VILLAGE OF ORLAND PARK

Tuesday, April 16, 2019

Plan Commission

[2018-0619](#) Tommy's Car Wash - Development Petition for Site Plan, Landscape Plan, Elevations, Special Use Permit Amendment with Modifications

DRAWING NO.
C1.0

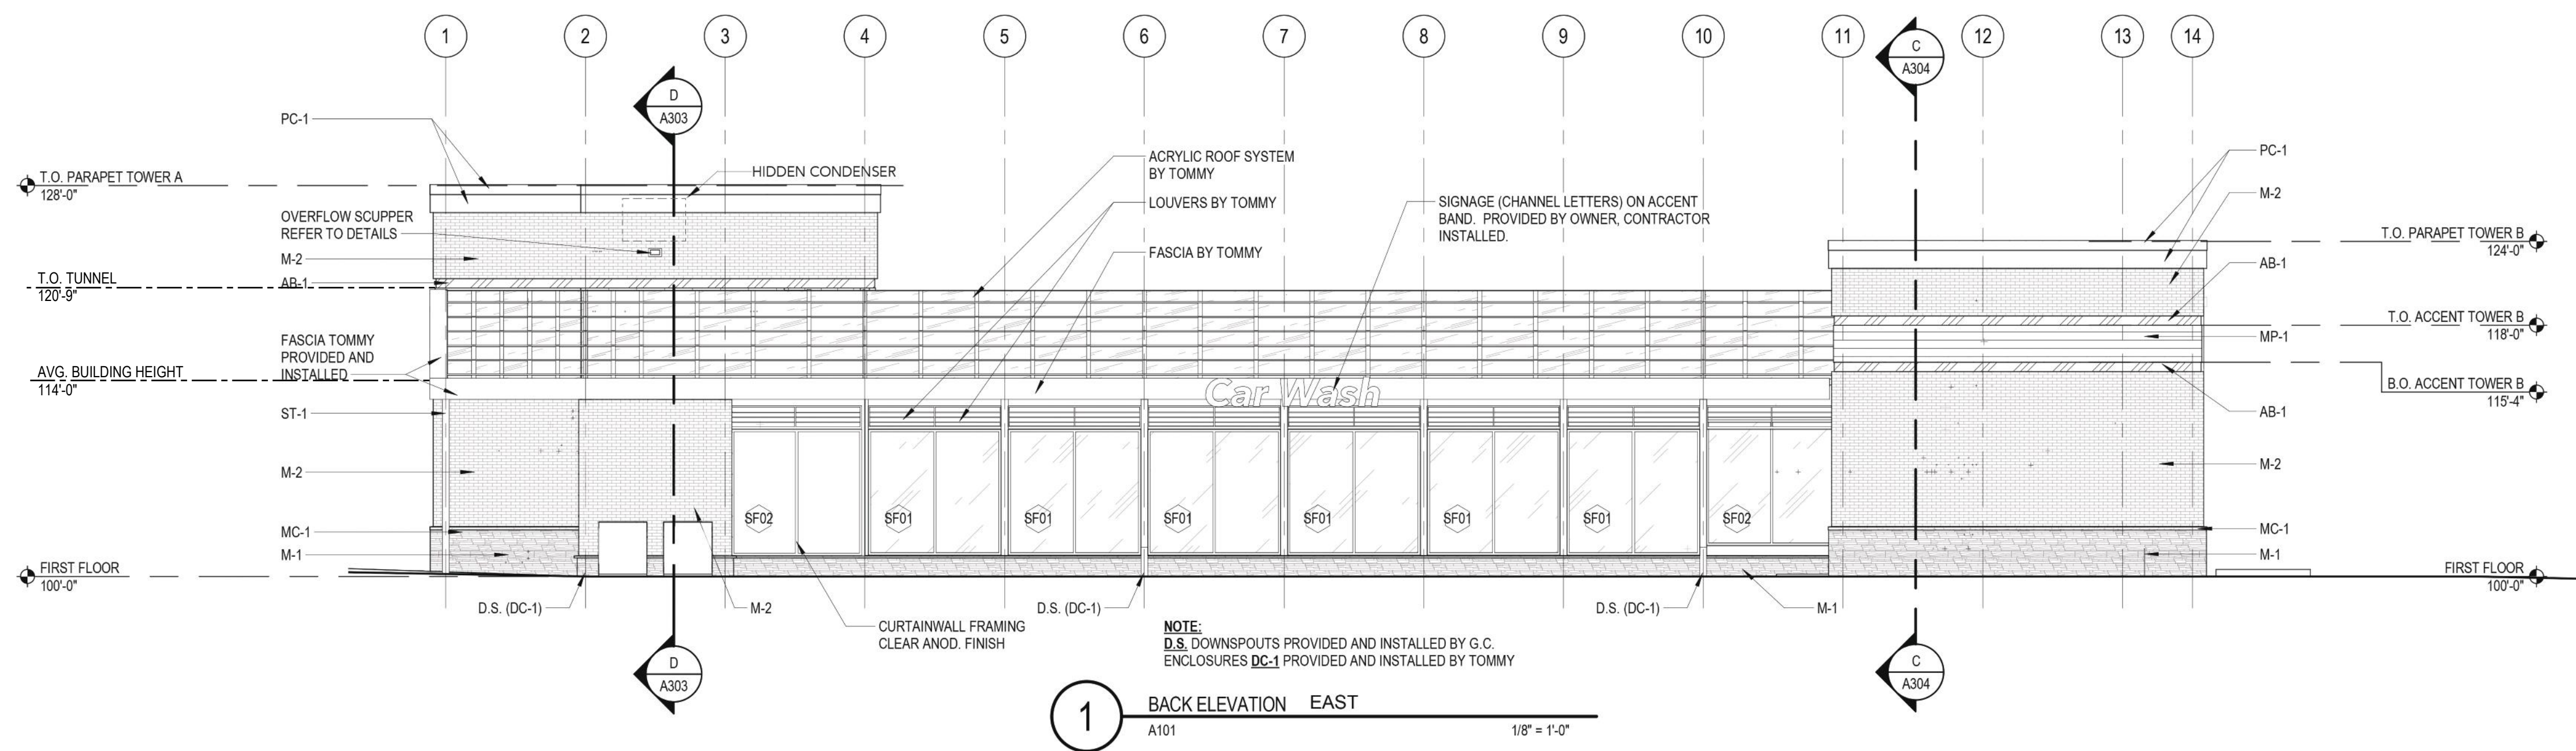
I move to recommend to the Village Board approval of the **Preliminary Site Plan** titled "Preliminary Site Plan", prepared by V3 Companies, Sheet C1.0, dated August 31, 2018 and last revised April 1, 2019, subject to the following conditions:

5 DUMPSTER ENCLOSURE - FRONT ELEVATION
A305 1/4" = 1'-0"

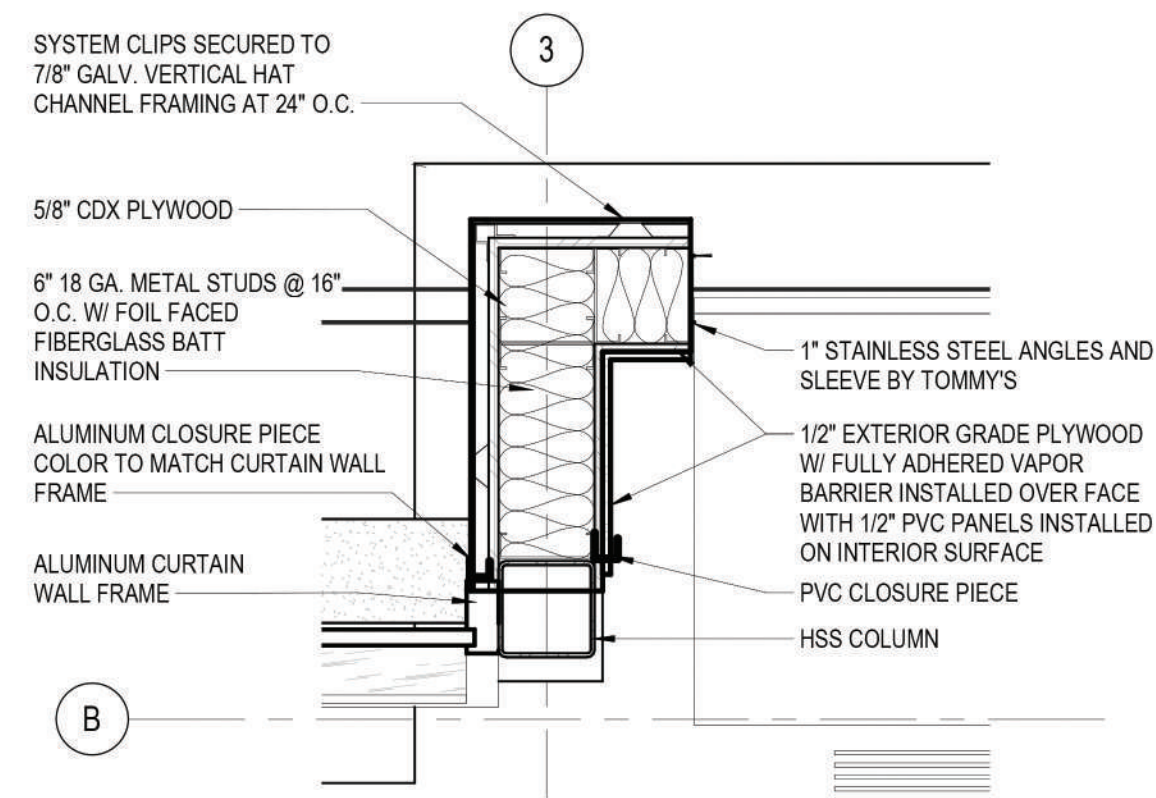
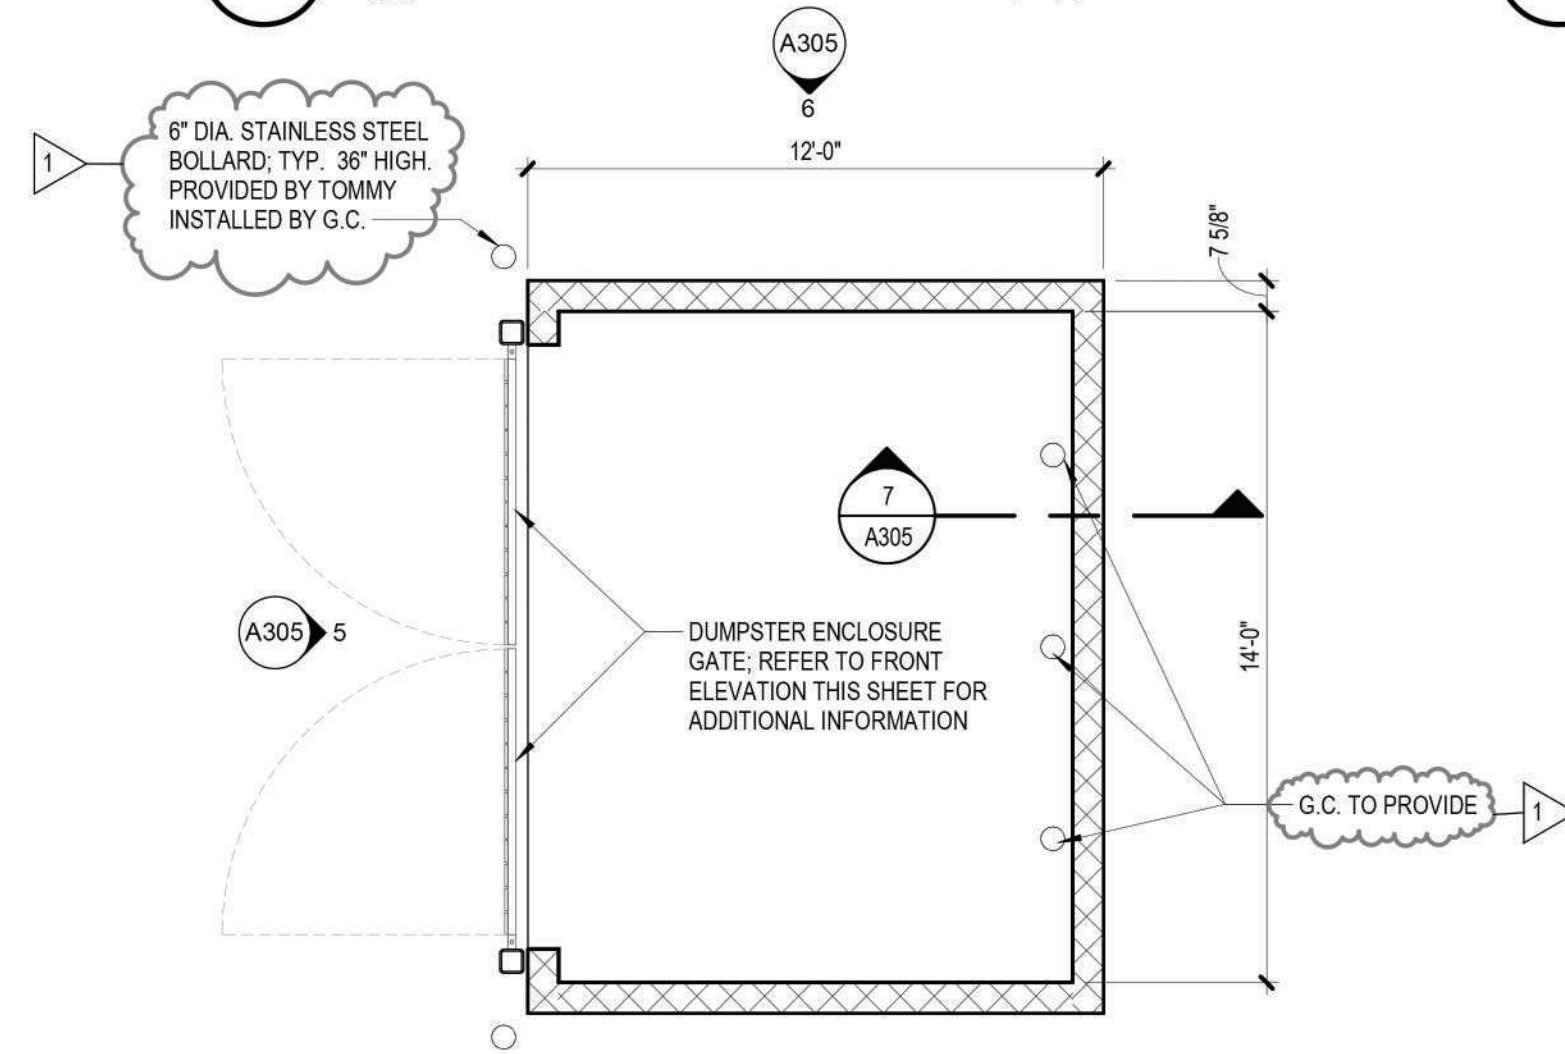
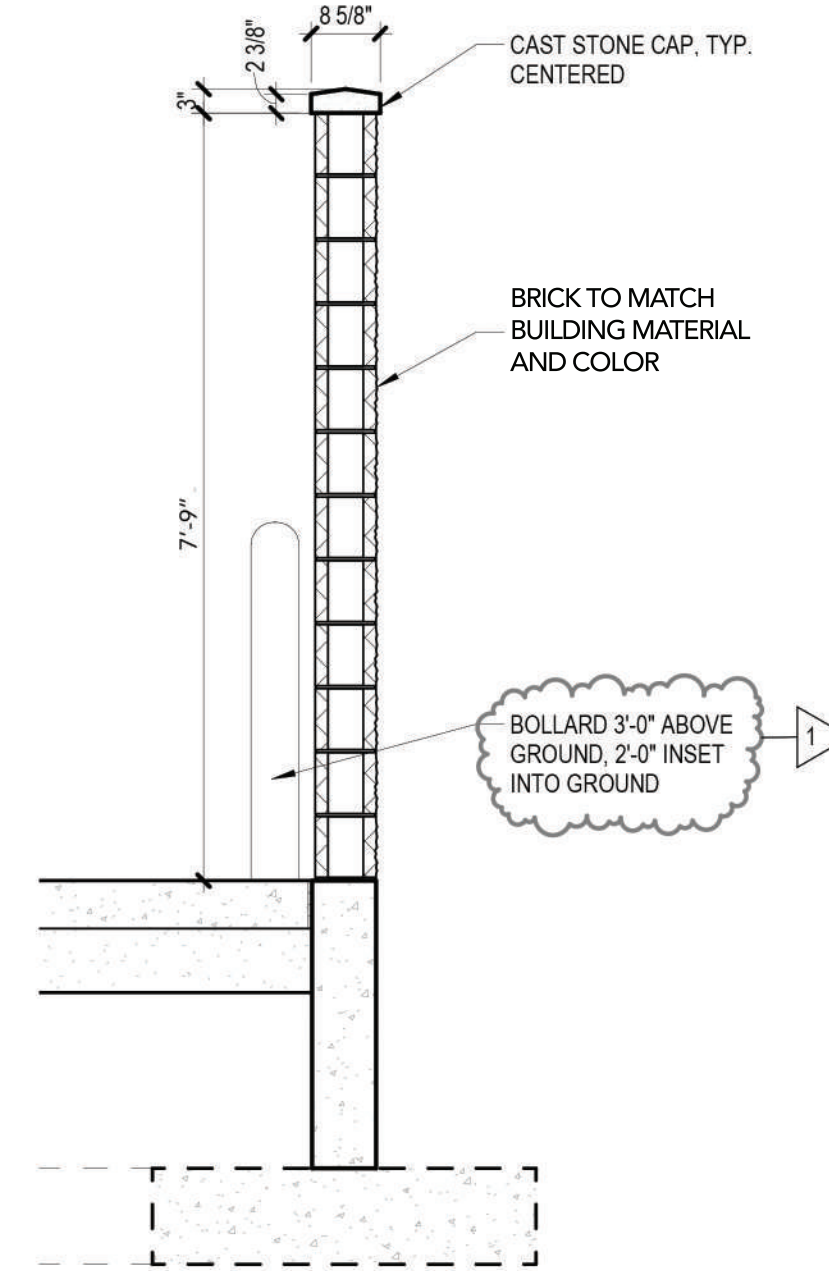
Garbage Enclosure - A garbage enclosure is proposed on the east side of the site near the north cross access drives. As shown on the elevations, Sheet A305, the enclosure will be constructed of eight (8) foot tall brick walls that will match the brick used on the building and six (6) foot tall wood gates. As proposed, the garbage enclosure meets the requirements of the Land Development Code.

I move to recommend to the Village Board approval of the **Elevations** titled "Exterior Elevations", Sheet A201, dated July 27, 2018, and "Building and Wall Sections", Sheet A305, dated September 20, 2018, prepared by Progressive Architecture Engineering, PC, subject to the following conditions:
